**49 CFR Part 571
Federal Motor Vehicle Safety Standards;
Child Restraint Systems; Final Rule**

[Docket No. NHTSA-03-15351]

Federal Motor Vehicle Safety Standards; Child Restraint Systems

ACTION: Final rule.

SEAT ORIENTATION REFERENCE LINE AND BELT ANCHORAGE POINT LOCATIONS ON THE STANDARD SEAT ASSEMBLY
Figure 1A

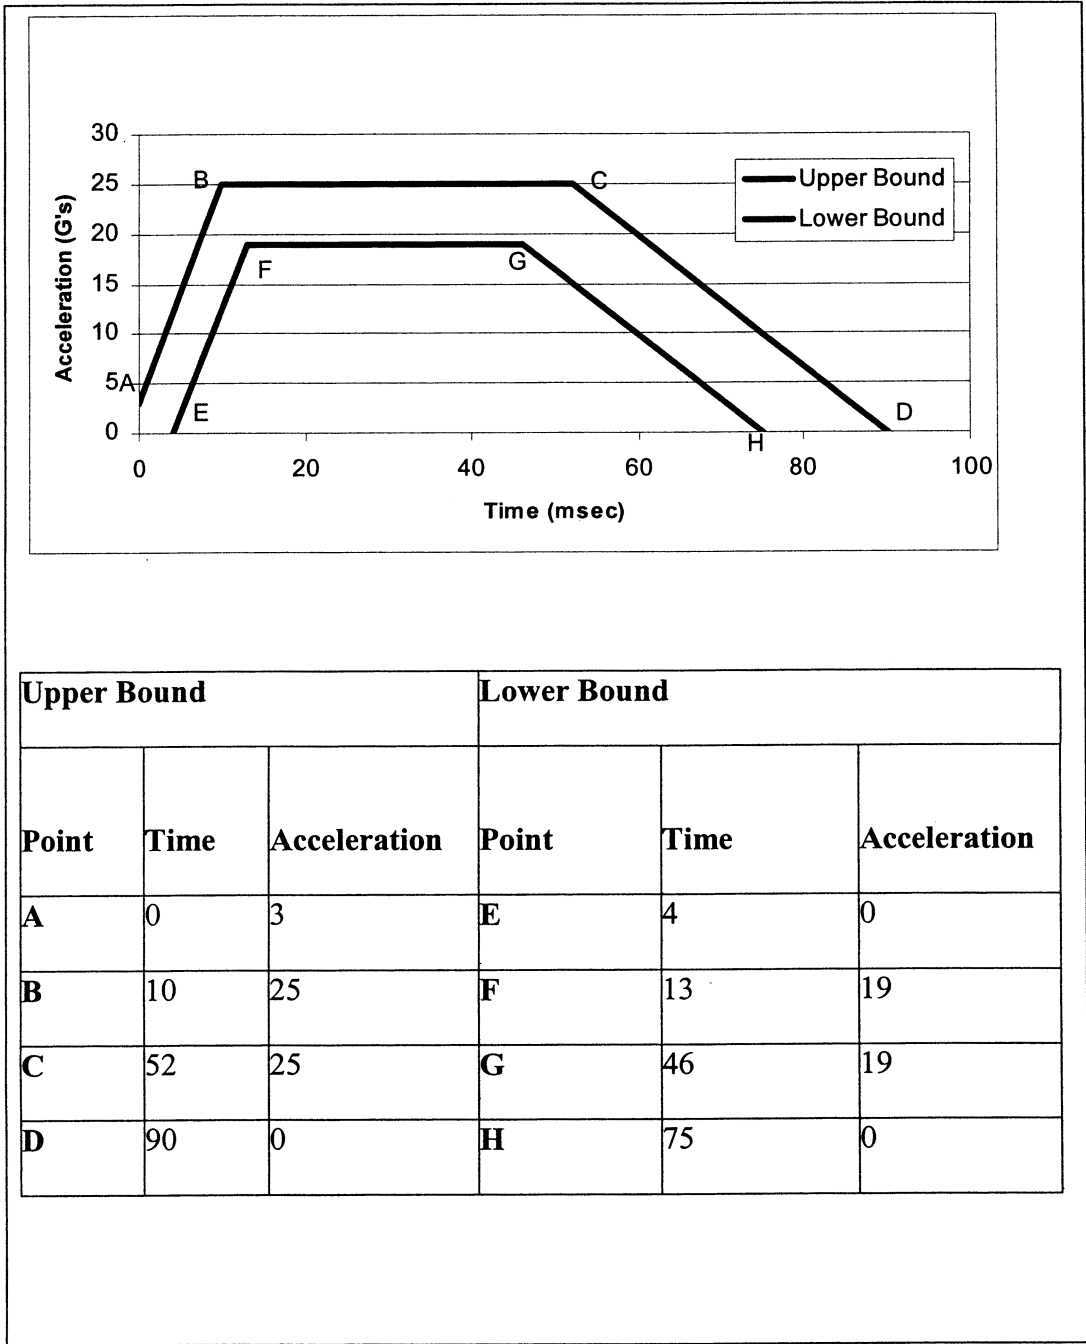
Figure 1A of FMVSS No. 213 is revised to reflect the above changes, as is the drawing package of the seat assembly that is incorporated by reference into the standard. (This final rule makes a technical amendment to 49 CFR 571.5 to provide information on obtaining copies of the drawing package).

- a. Revising the definition of "child restraint system" in S4;
- b. Adding S5(d);
- c. Revising the introductory text of S5.1.2;
- d. Adding S5.1.2.1 and S5.1.2.2;
- e. Revising the table to S5.2.1.1(a);
- f. Revising the introductory text of S5.2.1.2,
- g. Revising S5.2.3.1 and S5.9(a);
- h. Revising S6.1.1(a)(1), S6.1.1(b)(1) and S6.1.1(d), and the introductory text of S6.2.3;
- i. Revising S7, and S9.1(c);
- j. Adding S9.1(d), S9.1(e) and S9.1(f);
- k. Revising S9.3, S10.2.1(b)(2), S10.2.1(c)(1)(i) introductory text, and S10.2.1(c)(2);
- l. Revising Figure 1A; and,
- m. Adding Figure 2A.

This final rule adopts the proposals, except the spacing between the anchors of the lap belt in the center seating position will be 400 mm, rather than 392 mm as proposed. The agency believes that the 8 mm difference between 400 and 392 mm is negligible, yet the 400 mm specification will make the spacing identical to that of the test seat assembly of ECE Regulation 44, so it is adopted. The lap belt anchorage spacing in the outboard seating position is revised to 472 mm, as proposed. (The ECE regulation specifies a spacing of 400 mm for both lap only tests and lap/shoulder tests. The agency cannot conclude that the difference between 472 mm and 400 mm is insignificant, so the agency is not adopting the ECE specification.) In response to Ms. Bidez, the Federal motor vehicle safety standards specify a minimum spacing for the anchorages, not a maximum. As to setting the anchorages at the maximum spacing that the agency has measured in its test program, the agency declines this suggestion. The agency does not have sufficient information to form the basis for a conclusion that a safety need exists to set the anchorages at the widest spacing observed on a vehicle seat. Further, setting the anchorages at the maximum spacing was not proposed in the NPRM or evaluated in the agency's test program at PAX River.
